UNITED STATES PATENT AND TRADEMARK OFFICE

APPLICATION NO.	FILING DATE	FIRST NAMED INVENTOR	ATTORNEY DOCKET NO.	CONFIRMATION NO.
10/049,862	02/19/2002	Max Roth	032553-021	2349

Office Action Summary

DETAILED ACTION

FIGURE A: THE MODIFIED FIGURE CORRESPONDES TO FIGURE 4 WITH LIMITATIONS SHOWN

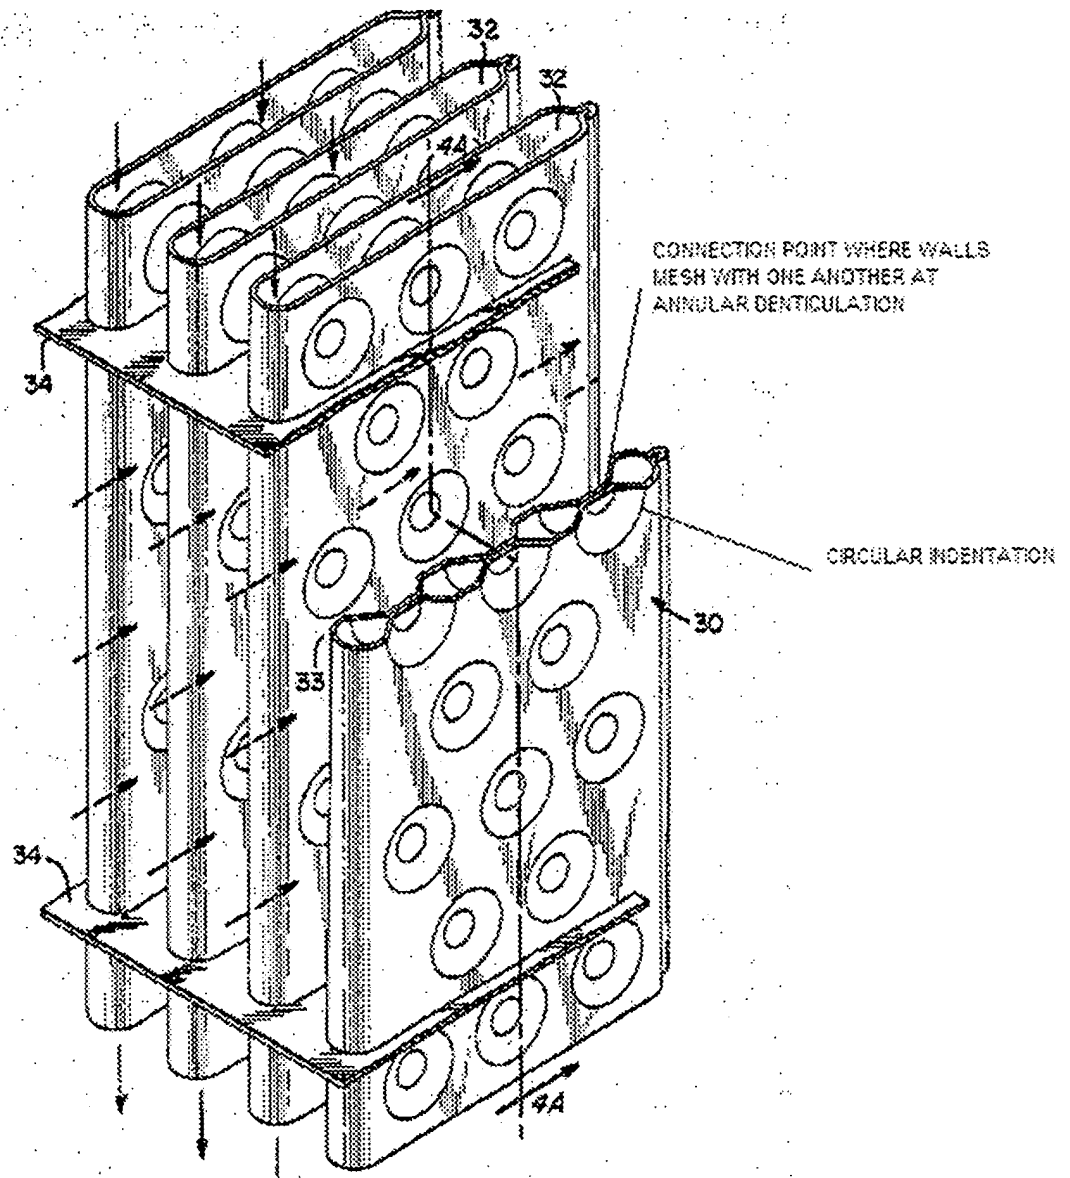
Claims 10-14, 17, 19, 22-23 and 26 are rejected under 35 U.S.C. 102(b) as anticipated by or, in the alternative, under 35 U.S.C. 103(a) as obvious over Kun (US 3,757,855). Kun discloses (figures 2a, 4, 4a and column 6, lines 37-47) a construction kit for a radiator cooling system comprising a plurality of heat exchangers (30); plug connectors (8) for the connection of the heat exchanger; and a tank (10), which is capable of containing hot water. The heat exchanger (21) comprising a two joined together copper walls, which has a thickness of 0.076-6.35 mm, forming a flow through chamber (32) for a heat transfer medium, the walls being joined together at a plurality of connecting points (22) inside a surface between edges of the heat exchanger, wherein the wall mesh with one another at the connecting points (Figure A). Kun further discloses that the annular denticulations are spaced apart at a distance D from 5 mm to 63 mm. The method of forming the device "punctuate fastened", "compression molded annular denticulations" and "are produced by an upsetting-pressing process and without penetration of sheet metal used to form the walls" are not germane to the issue of patentability of the device itself. "[E]ven though product-by-process claims are limited by and defined by the process, determination of patentability is based on the product itself. The patentability of a product does not depend on its method of production. If the product in the product-by-process claim is the same as or obvious from a product of the prior art, the claim is unpatentable even though the prior product was made by a different process." In re Thorpe, 777 F.2d 695, 698, 227 USPQ 964, 966 (Fed. Cir. 1985). In this case, the heat exchanger in the product-by-process claim is the same as or obvious from

the heat exchanger of the Kun, the claim is unpatentable even though the prior heat exchanger was made by a different process.
